TOWN OF SIDNEY

Report to Advisory Planning Commission

TO: Chair and Members
FROM: Celina Fletcher, Municipal Planner
DATE: October 31, 2024 File No. 9899 Seventh Street (Land)
SUBJECT: Development Permit Application No. DP100848
Development Variance Permit Application No. DV100360
9895 and 9899 Seventh Street

DP10

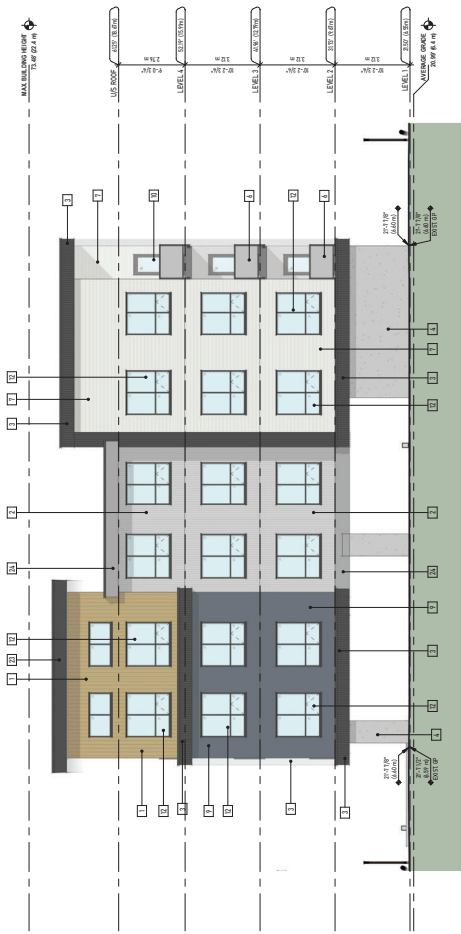
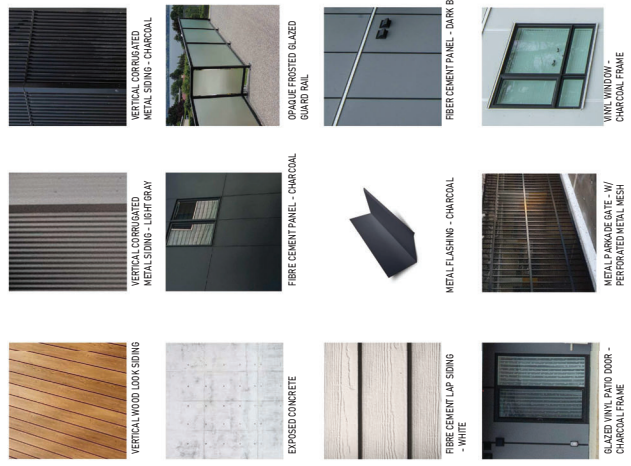
The surrounding neighborhood is largely developed with residential uses at a variety of different densities and heights. Sheet DP10 of the proposed plans demonstrates the height of the proposed building in relation to buildings on adjacent neighboring properties. At four storeys the proposed building is noticeably taller than the immediately adjacent buildings, however, it is consistent with the height and lot coverage of the RM7 zone and a recently completed building to the north at 2319 Brethour Avenue. Design-wise, the building reflects the design of newer existing buildings in the neighbourhood in terms of colours, materials, and architectural style, which can help to create a visually consistent street frontage along Seventh Street, with consistent building facades and similar front setbacks. However, the proposed building is notably different from its immediate neighbours to the north, with a largely flat roof and contemporary exterior materials and design.
